A G E N D A
DESIGN REVIEW COMMITTEE

STAFF REPORT AND FINDINGS OF FACT

SUBJECT: Design Review Request (DR14-01) by Patrick McGee for Donna and Tracy Black to construct a single-family dwelling at 2505 Mill Pond Lane

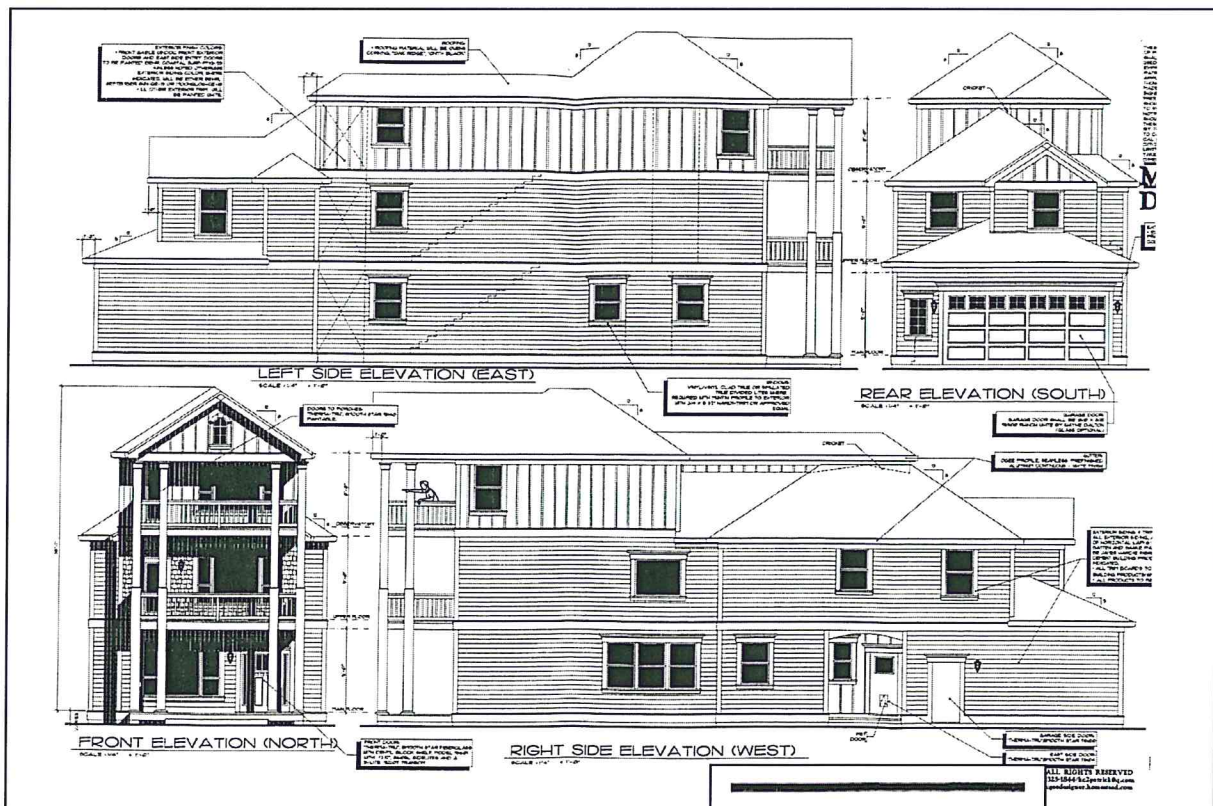
Finding: All windows are vinyl clad wood and are fixed or single hung. The windows are rectangular and vertical, paired and set of three. Front porches have simulated multi-lite and large single lite. There is one multi-lite window on the rear. All lites will need to be true divided or have external muntins. Windows should be inset from the plane of the facade (Condition 1). There are no blank walls.

1. Windows and casings shall be installed so that the windows do not protrude beyond the casing; and so that the casing protrudes beyond the plane of the siding. Any windows with grids shall be true divided or shall have external grids.
2. Exterior light fixtures shall have diffused lighting.

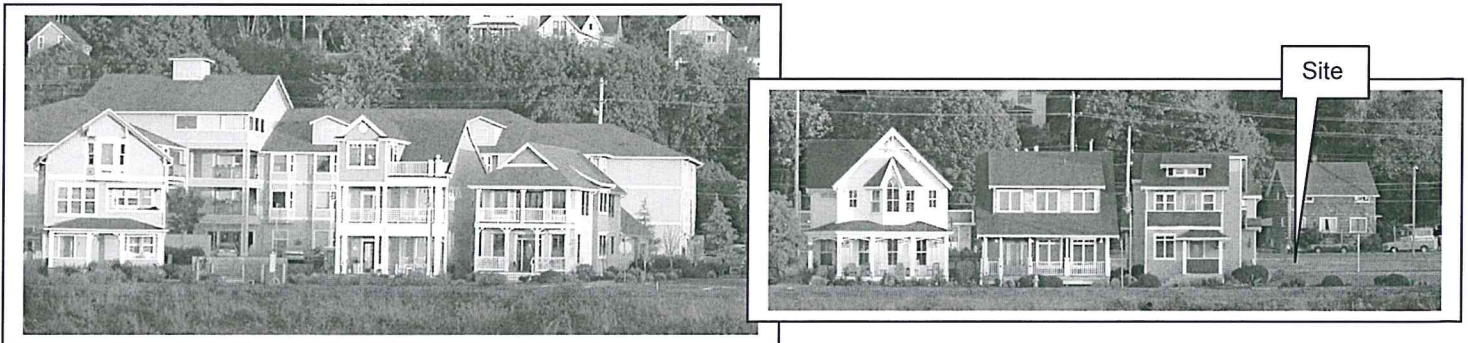
Finding: There are one, two, and three story residential buildings in the Uppertown area. Buildings in Mill Pond Village include one, two, 2.5, and three story structures. The proposed structure is 3 stories. Structures in the Uppertown area have a mixture of wood, cement, and fiber cement siding. New residences in Mill Pond have a mixture of wood and fiber cement siding. The use of fiber cement horizontal and board and batten siding materials is characteristic of and harmonious with the buildings in the surrounding area and the character of the waterfront.
